Model: Neptune-P1	Date: 27-Aug-07	No.: RG180001a
-------------------	-----------------	----------------

Subject: Firmware Release Note: Engine		Prepared by: F.Noguchi	
From: 2nd Tech. Support Sec. Service Support Dept.			
Classification:	<input type="checkbox"/> Troubleshooting <input type="checkbox"/> Mechanical <input type="checkbox"/> Paper path <input checked="" type="checkbox"/> Other ()	<input type="checkbox"/> Part information <input type="checkbox"/> Electrical <input type="checkbox"/> Transmit/receive	<input type="checkbox"/> Action required <input type="checkbox"/> Service manual revision <input type="checkbox"/> Retrofit information

This RTB has been issued to announce the firmware release information for the **Engine**.

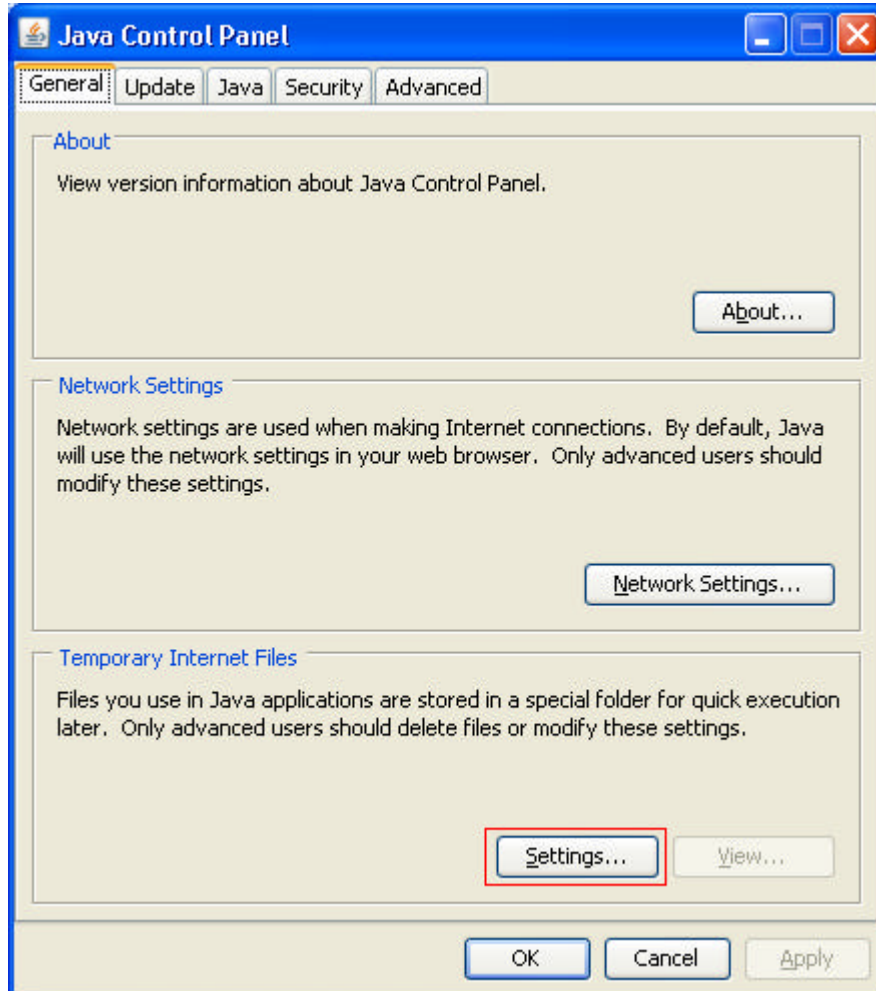
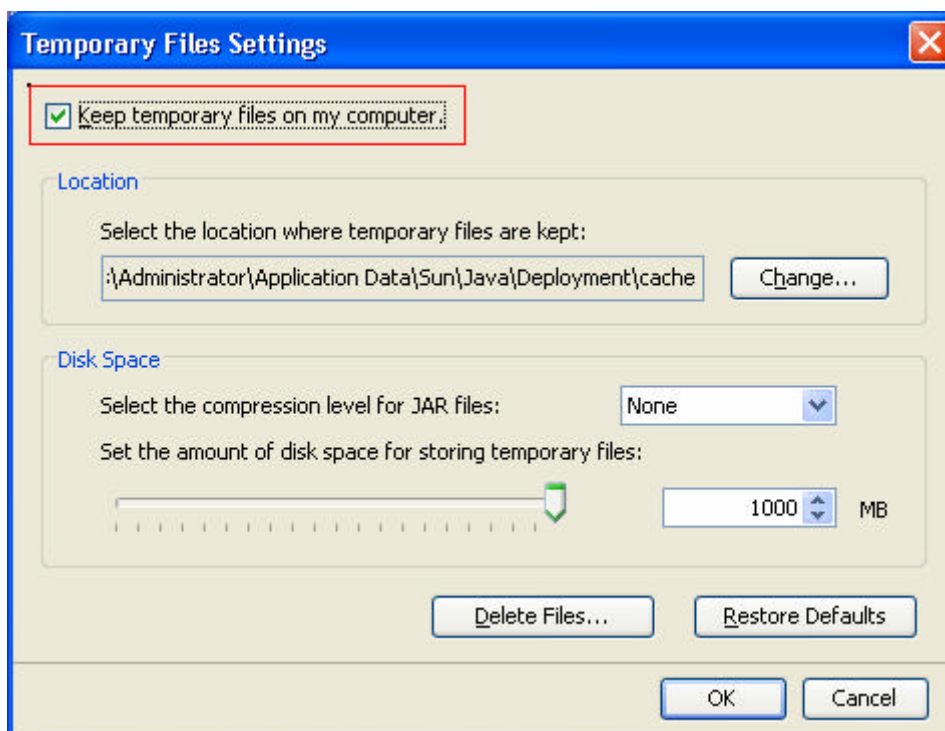
"Applet printtool.c2pl applet notinited" (error message) is displayed if WebPrint is used together with Java 6 Update 2, Version 1.6.0_2.

The default setting for "Temporary Internet Files" in the Java Control Panel was changed from Java 6 Update 2, Version 1.6.0_2.

Change the "Temporary Internet Files" setting in the Java Control Panel.

1. Access the Java Control Panel.
2. From the "General" Tab, click the "Settings" button for Temporary Internet Files.

3. Uncheck the box next to "Keep temporary files on my computer".
4. Click "OK".
5. Go back to the "General" tab and click "Apply".
6. Click "OK".

Print_B7367059.pc

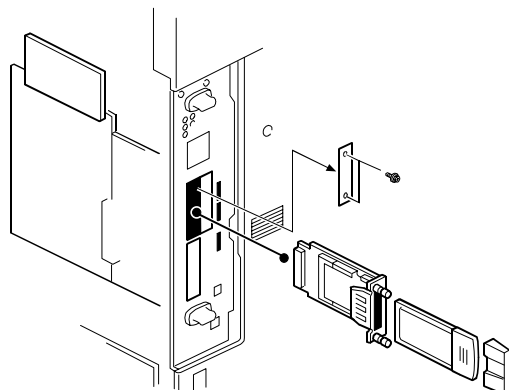
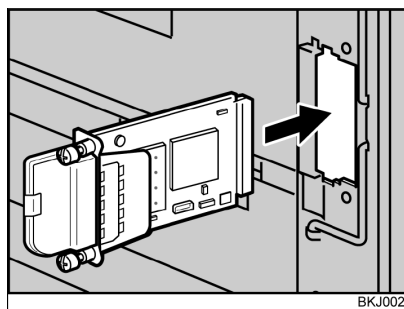
1. Production of a new wireless LAN option, the **IEEE 802.11b Interface Unit Type N**, began in March 2008. This will replace the current wireless LAN options listed below, as the vendor discontinued production on a key part contained in these options.
2. Make sure to see below for the target models and action in the field, including the necessary firmware versions.

Previous types:
PCB, LAN card, and cover are
separate

New Type (IEEE802.11b
Interface Unit Type N):
Pre-assembled
